AGENDA
CITY OF LAKE WORTH BEACH
HISTORIC RESOURCES PRESERVATION BOARD REGULAR MEETING
CITY HALL COMMISSION CHAMBER
WEDNESDAY, APRIL 13, 2022 -- 6:00 PM

MEMORANDUM DATE: April 4, 2022

RE: **531 North Lakeside Drive**

TITLE: **HRPB Project Number 21-00100315:** Consideration of a Certificate of Appropriateness (COA) for garage and French door replacements for a building located at 531 North Lakeside Drive; PCN# 38-43-44-21-15-164-0090. The subject property is a contributing resource within the Old Lucerne Historic District and is located in the Single Family Residential (SFR) zoning district. The future land use designation is Single Family Residential (SFR).

Exhibit A: Proposed New Construction – Street View

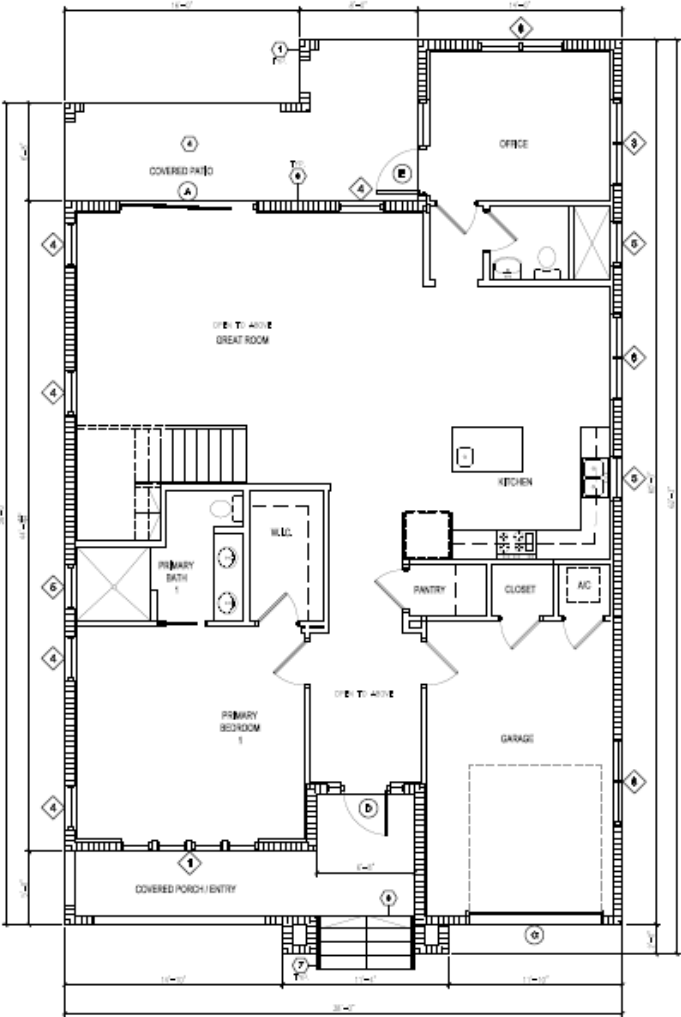
STAFF RECOMMENDATION: Staff recommends that the Board discuss whether the proposed building design is consistent with the previous direction by the HRPB, including compatibility with height and massing. Further, the HRPB is also tasked in the City’s Land Development Regulations (LDRs) to determine if the new single-family structure is consistent with the Historic Preservation Design Guidelines criteria for new construction. The proposed single-family site plan is generally consistent with the LDRs and will be reviewed for final approval at building permit for each lot.

Exhibit A: Proposed New Construction – Street View

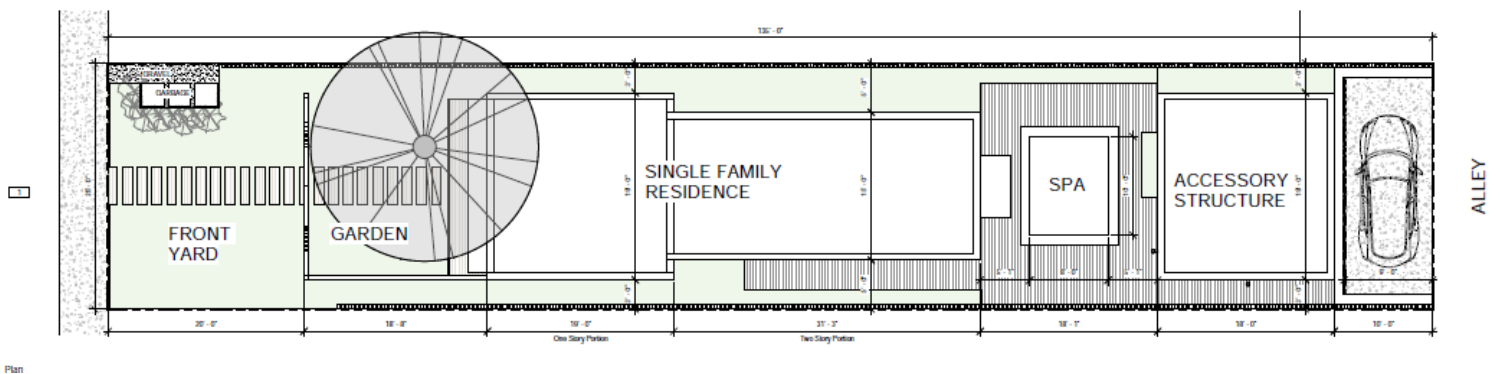
STAFF RECOMMENDATION: Staff recommends that the Board discuss the demolition of the existing non-contributing structure and whether the proposed building design is consistent with the previous direction by the HRPB. Further, the HRPB is also tasked in the City's Land Development Regulations (LDRs) to determine if the new single-family structure is consistent with the Historic Preservation Design Guidelines criteria for new construction. The proposed single-family site plan is generally consistent with the LDRs and will be reviewed for final approval at building permit. Staff is recommending approval of the proposed application.

Exhibit A: Window locations

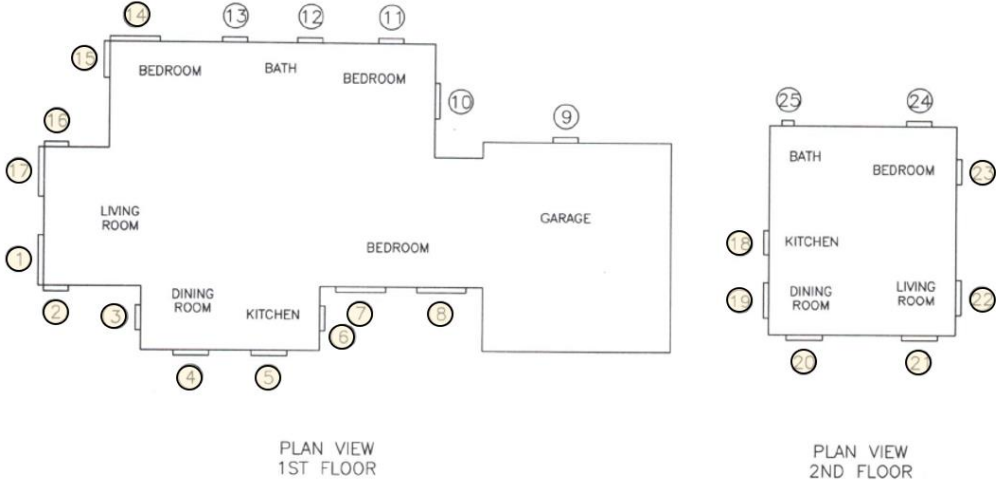
The contractor, Kline Construction Group, was not familiar with working in the historic district and has already purchased all 25 windows with gray glass. The COA application proposed to replace the existing awning windows with horizontal rollers replicating a four horizontal light window pattern with exteriorly applied, raised muntins.

- The use of horizontal rollers and applied muntins to replicate the look of horizontal divided lights.
- The use of gray glass in lieu of clear glazing.
